# Town of Hilton Head Island Regular Design Review Board Meeting

**TOWN OF HILTON HEAD ISLAND  
DESIGN REVIEW BOARD – NOTICE OF ACTION**

## DESIGN TEAM/DRB COMMENT SHEET

PROJECT NAME: The Westin – ALTERATION & ADDITION

**TMS LIGHTING - LUMINAIRE APPROVAL DRAWING**  
 PN: MD27316  
 TYPE: REV: 1

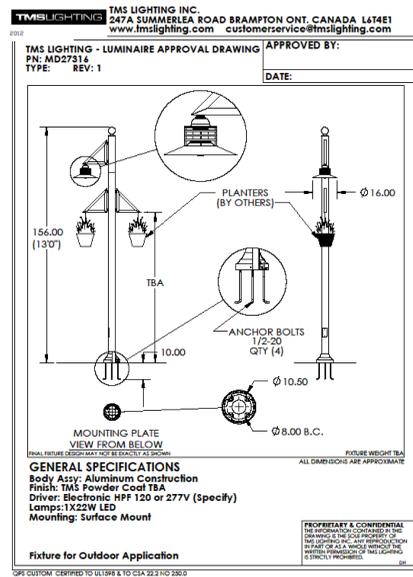
1. The fence along the entrance drive should be a darker color (can be staff approved).
2. The dolphin fountain cap should be thicker; 3" preferred (can be staff approved).
3. The light pole should be more simple and less Victorian in style (must return to DRB).
4. The gazebo should be less ornate and more in character with the previously approved alterations to existing architecture (must return to DRB).

The Westin proposes to replace existing site lighting fixtures with an architectural bronze fixture with hanging flower baskets. The previously submitted floating gazebo has been removed from the project.

The site lighting fixture locations will remain as submitted and upon DRB approval photo-metrics will be submitted for XDPR approval. Please see attached Sheet L-4 for locations. Also attached is the cut sheet for our selection. This fixture is to be a 22 Watt LED fixture in Architectural Bronze with hanging flower baskets that will be rotated seasonally to have fresh foliage throughout the year.

Staff recommends approval of this application as submitted.

**SITE LIGHTING PLAN**

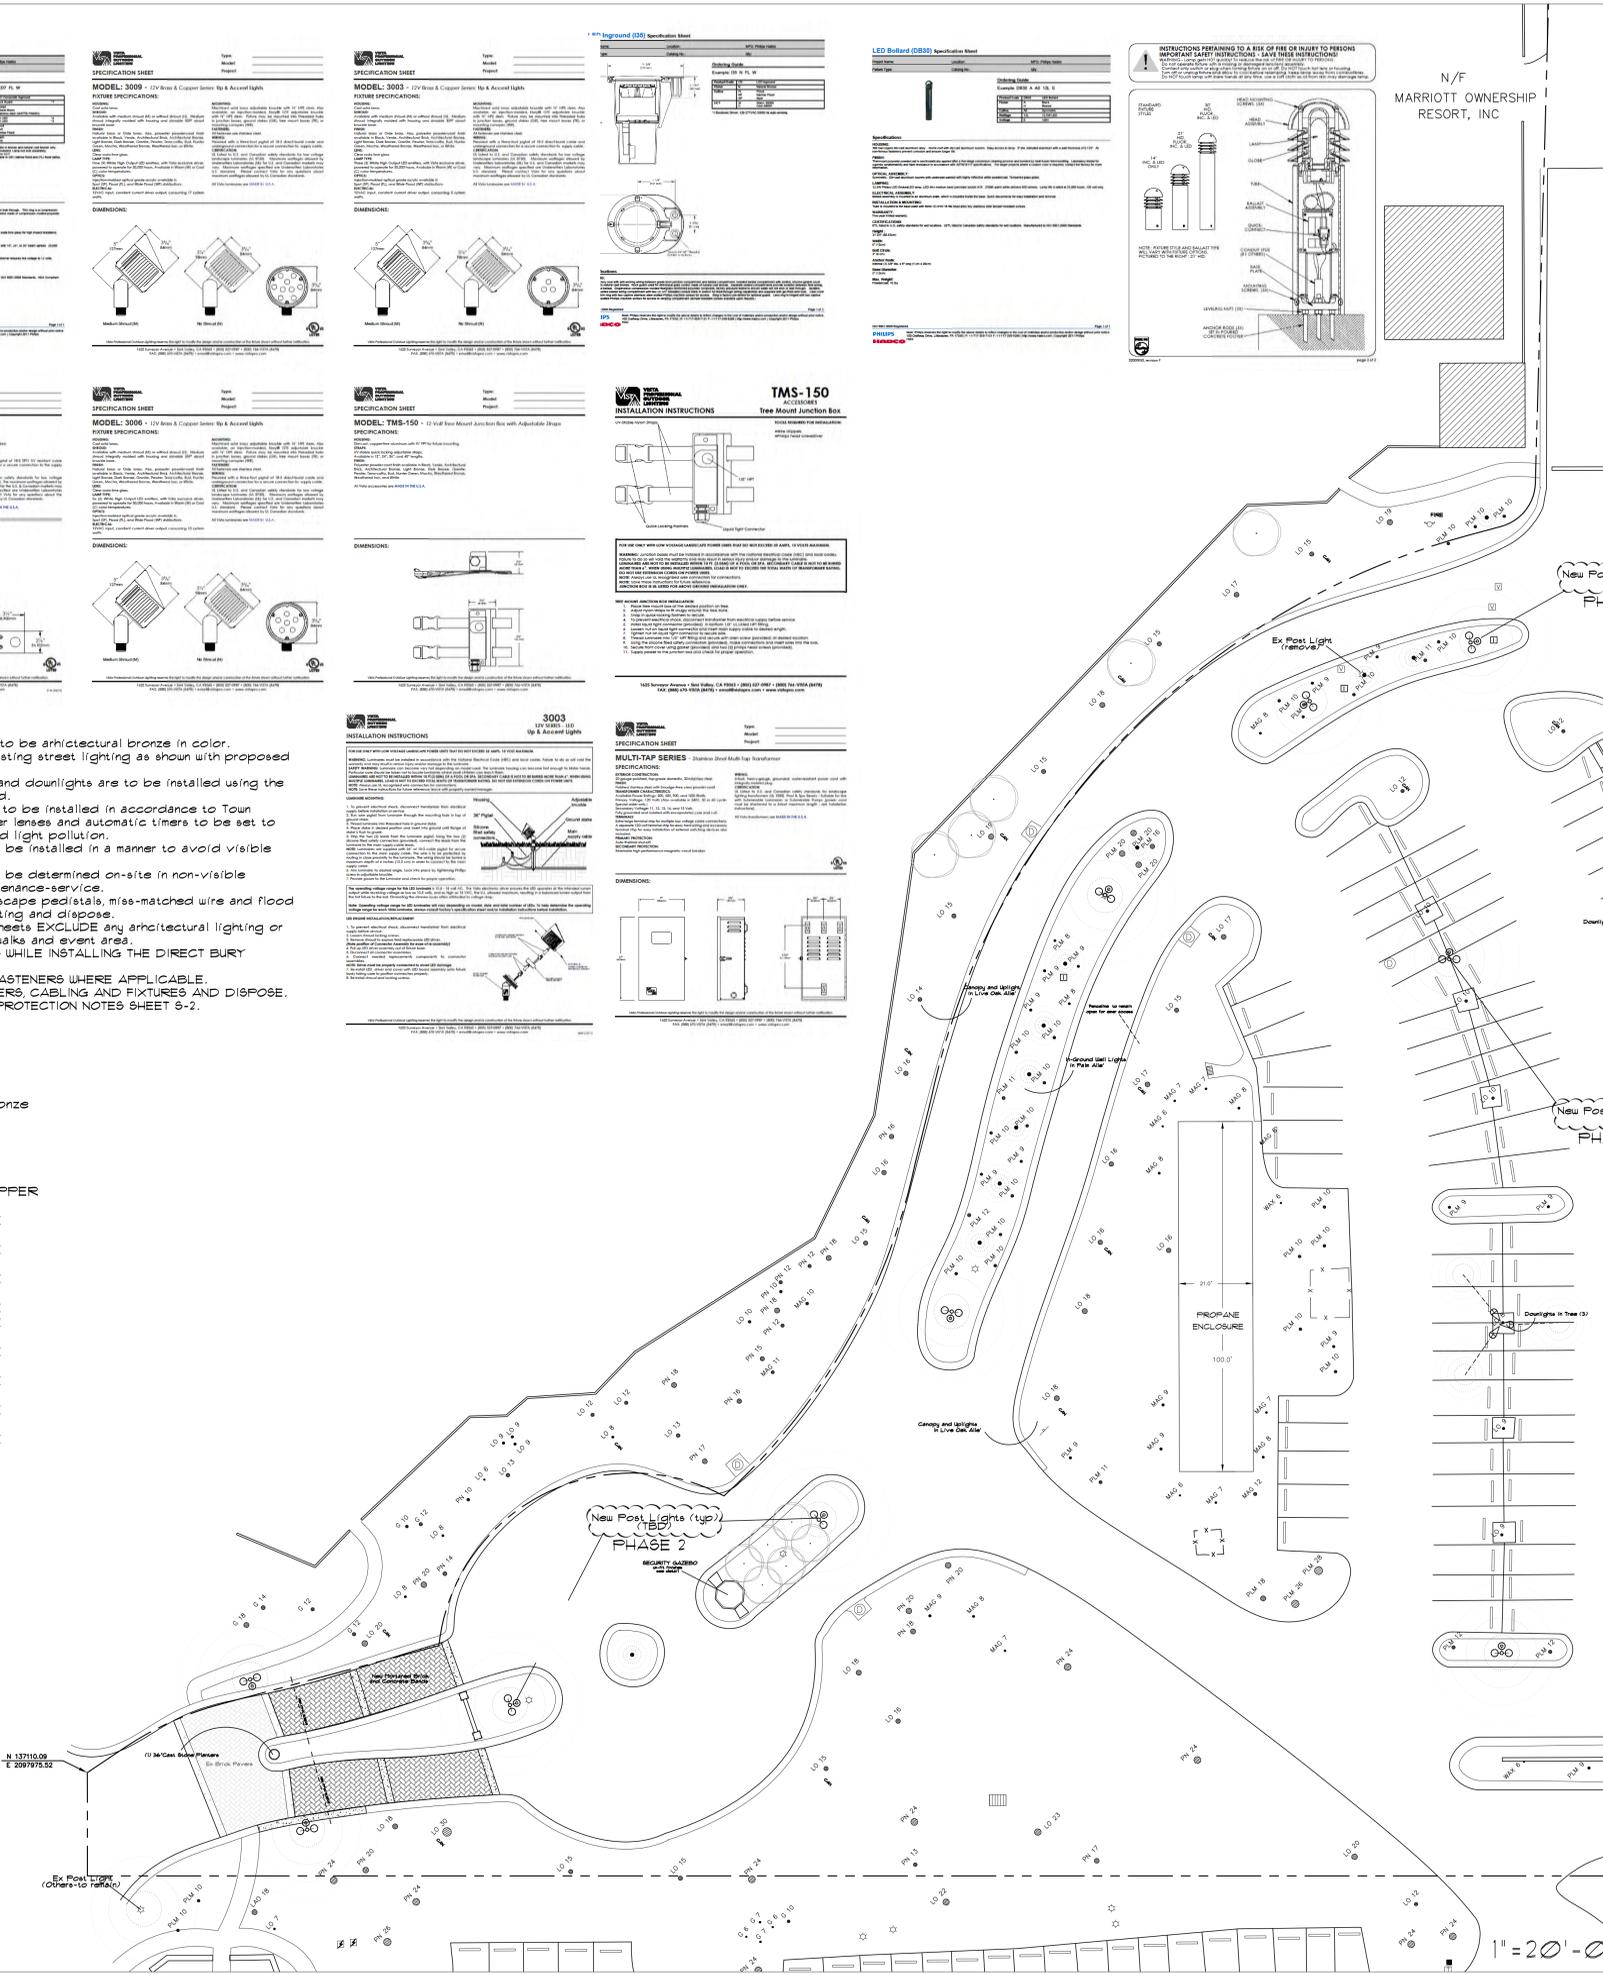
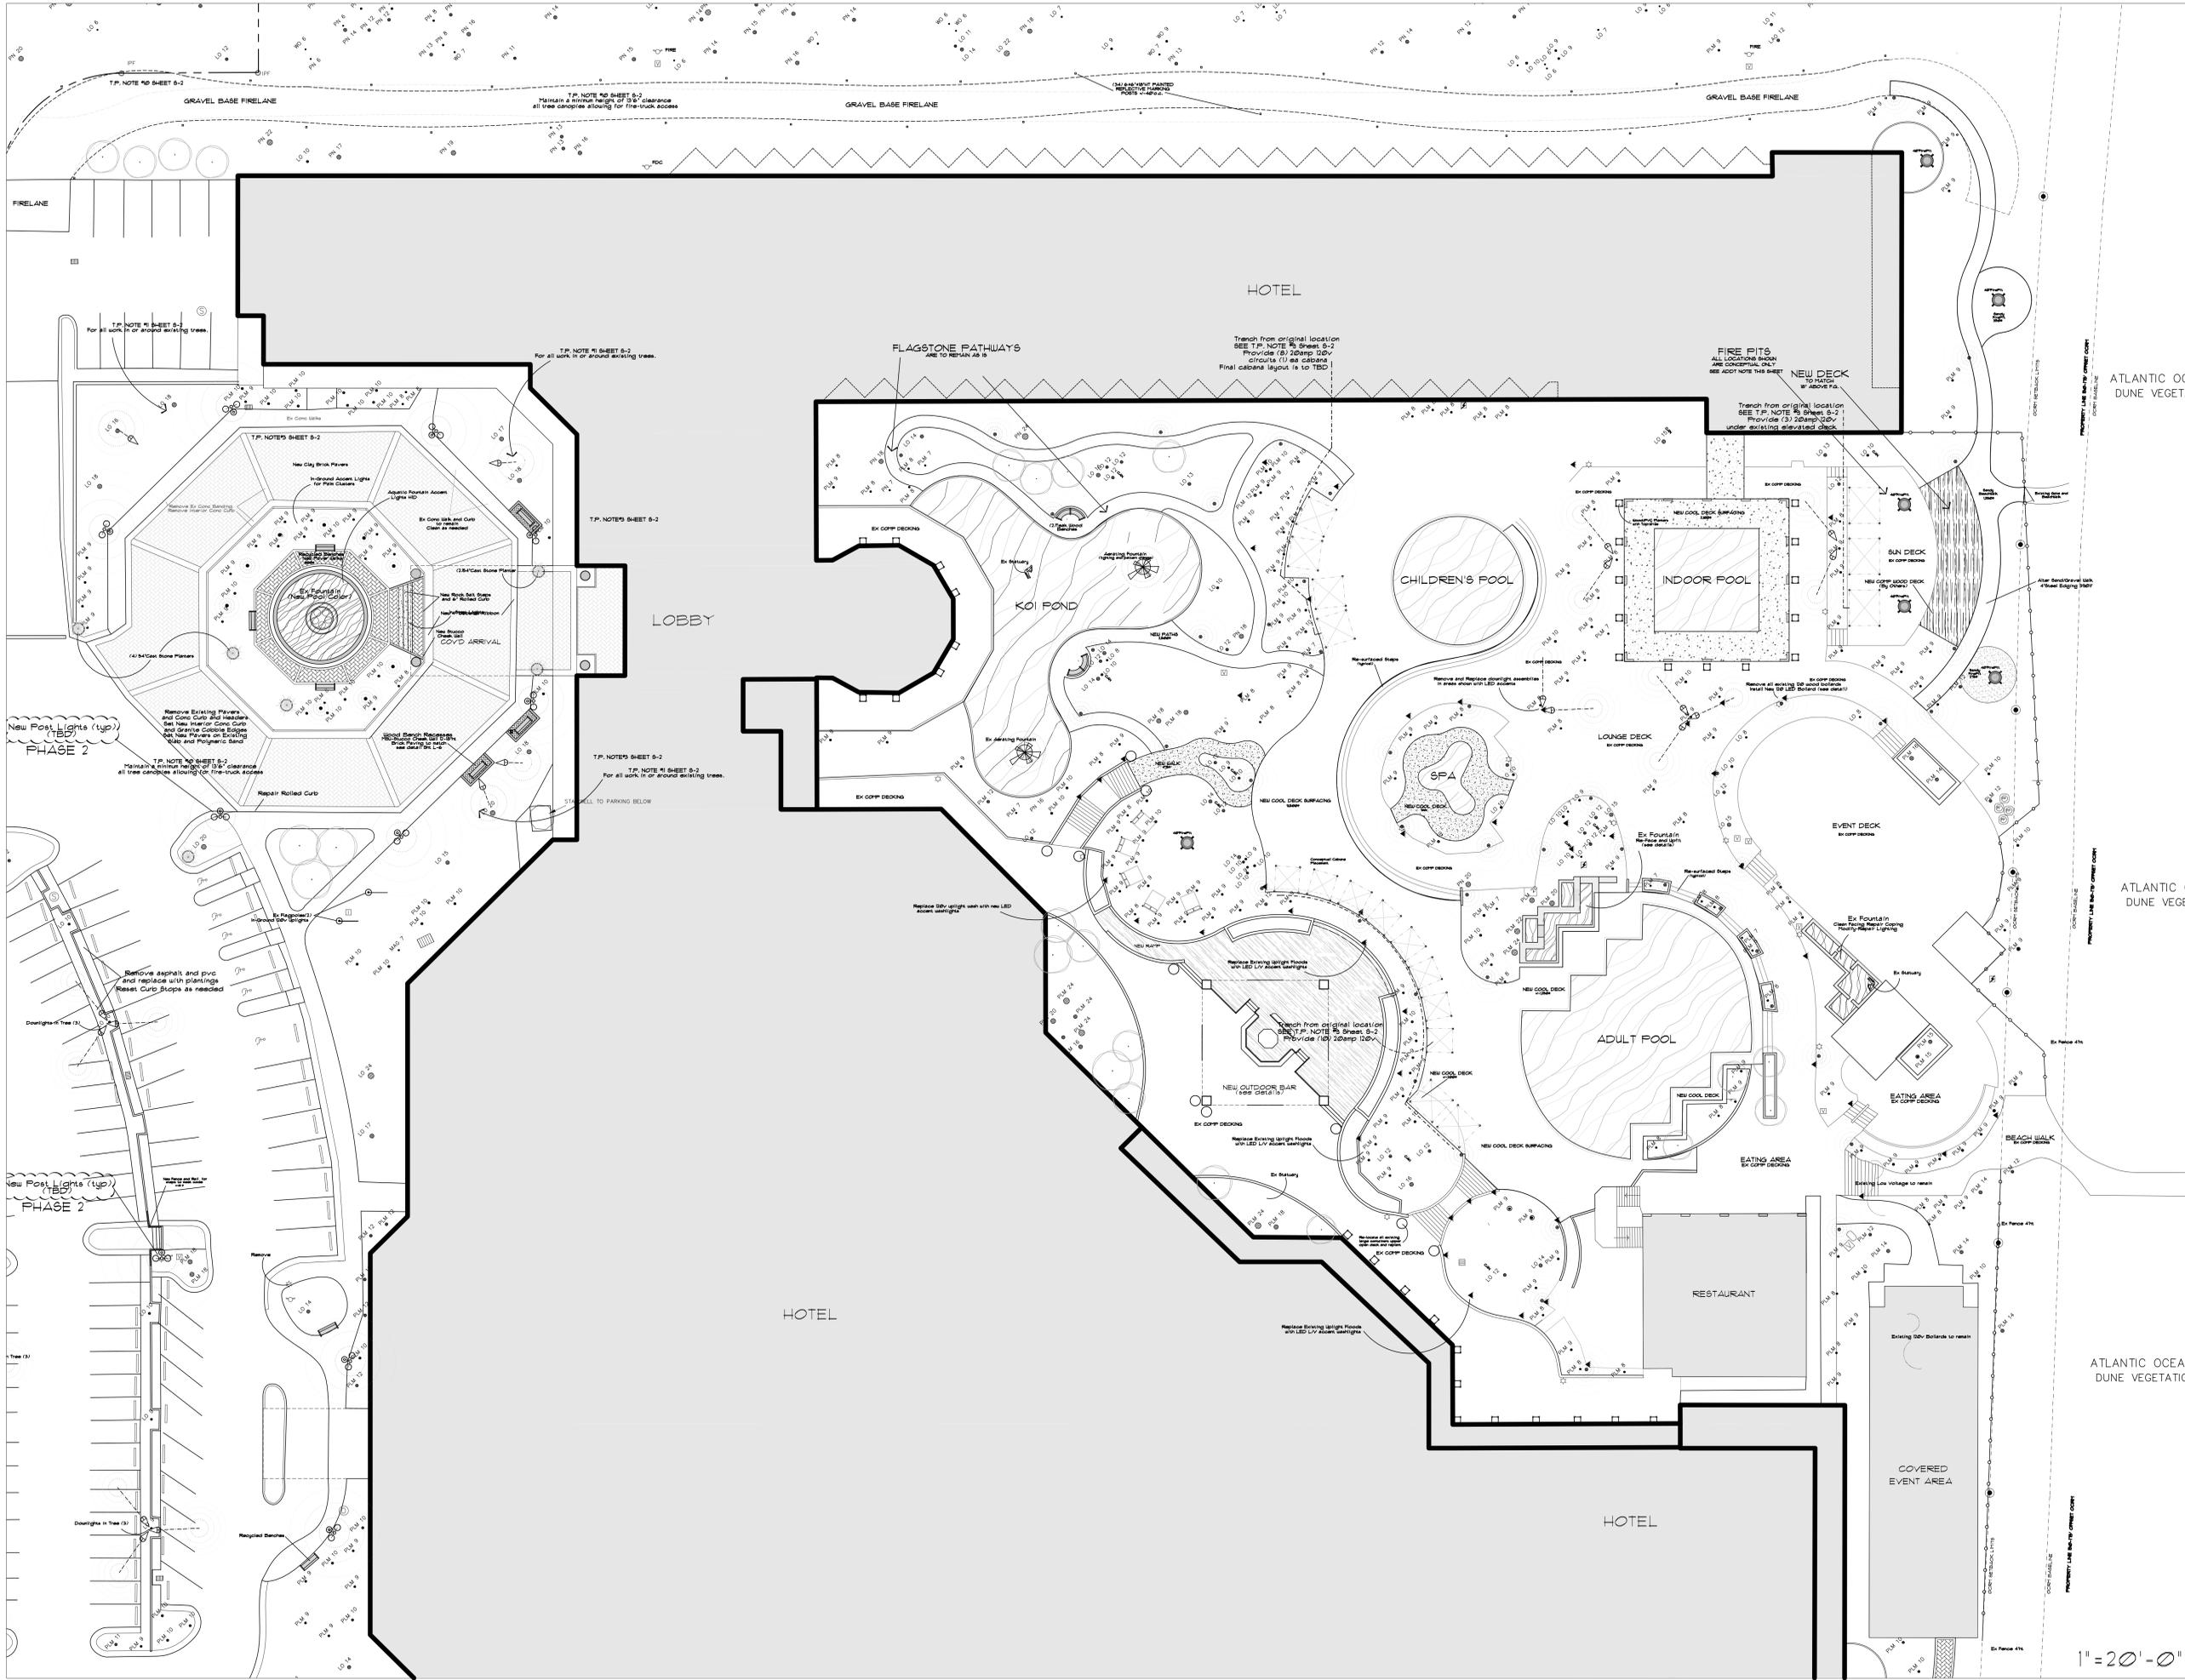
This submittal for the above referenced project #DR1200312 is for an alternate site lighting fixture as required from the DRB in the November 13, 2012 NOA item #3. This submission is for the Site Lighting Fixture only. At present the owners have decided to remove the "Floating Gazebo" from this scope of work and remaining items #1 and 2 will be submitted for staff review and approval.
